Wisconsin Department of Transportation

Proposal #13: 4327-08-71

Devils River Trail Bridge B-05-0438

Wall Street Bridge B-05-0439

Addendum No. 02
ID 4327-09-71
Added Sheet 4A
January 9, 2020

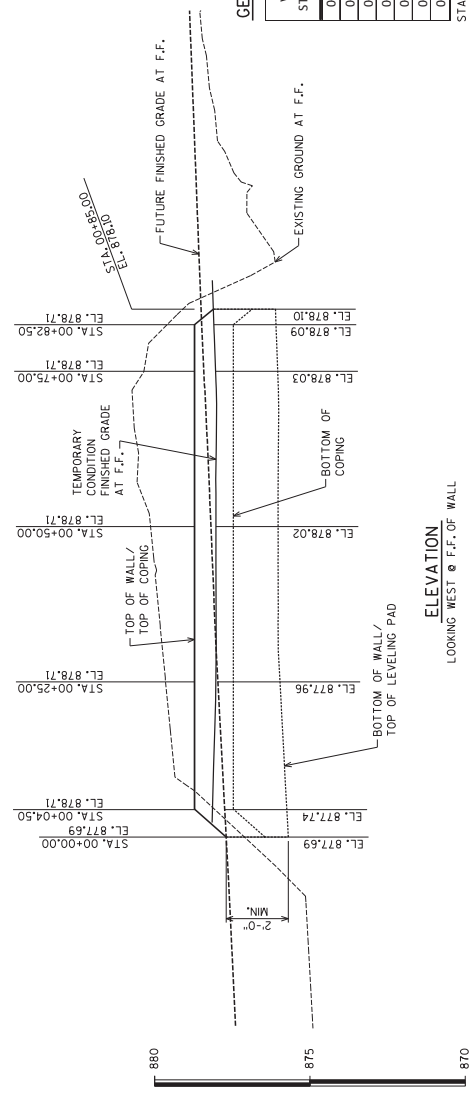
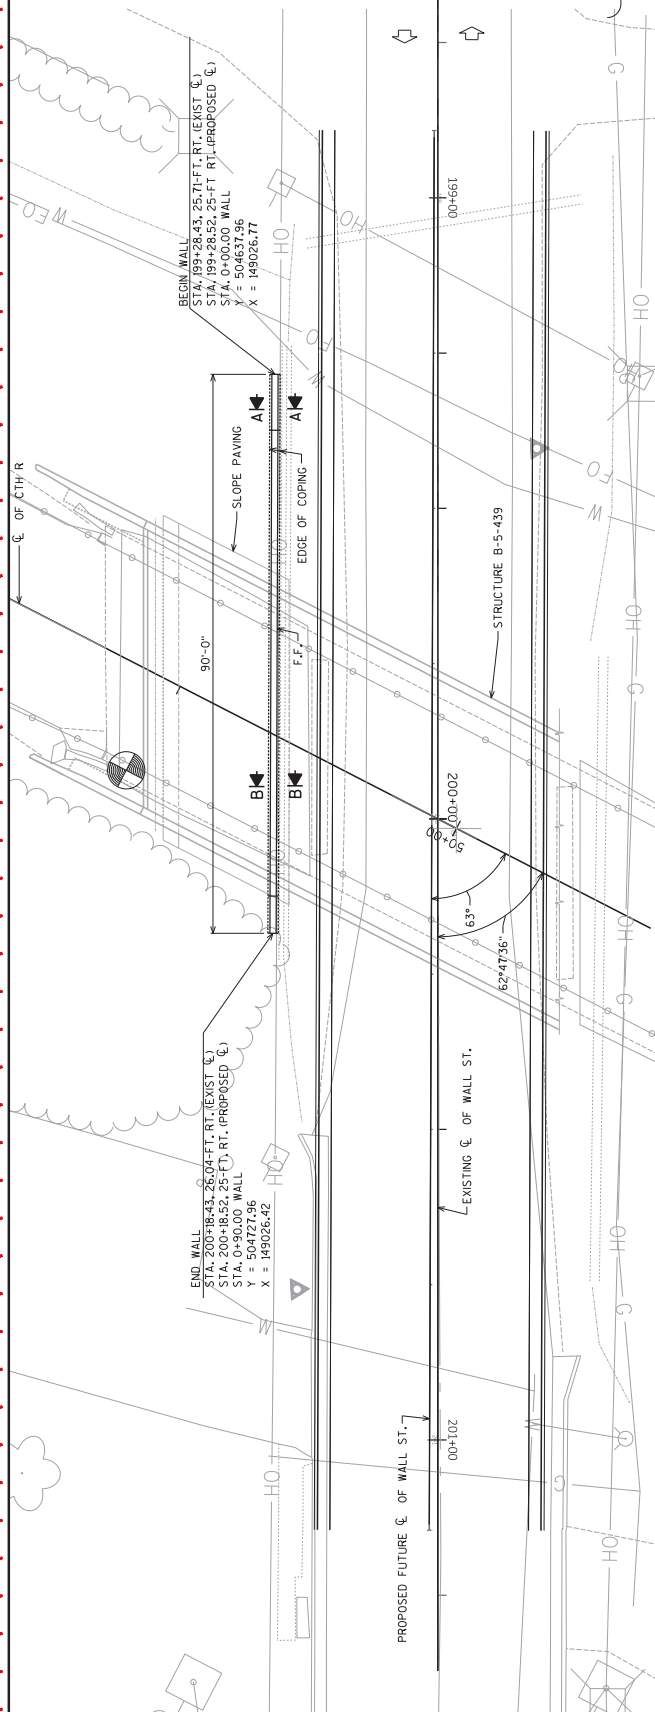
Added Plan Sheets – 4327-09-71	
Plan Sheet	Plan Sheet Title (brief description of why sheet was added)
4A	Retaining Wall Layout – West Abutment (Added retaining walls for future urban typical section for Wall Street)
4B	Retaining Wall Layout – East Abutment (Added retaining walls for future urban typical section for Wall Street)
4C	Retaining Wall Details – Design Data (Added retaining walls for future urban typical section for Wall Street)
4D	Retaining Wall Details – Typical Sections (Added retaining walls for future urban typical section for Wall Street)

ITEM NUMBER	BID ITEMS	UNIT
612.0406	PIPE UNDERDRAIN WRAPPED 6-INCH	105 LF
SPV.0165.01	WALL MODULAR BLOCK GRAVITY LANDSCAPE WEST ABUTMENT	235 SF
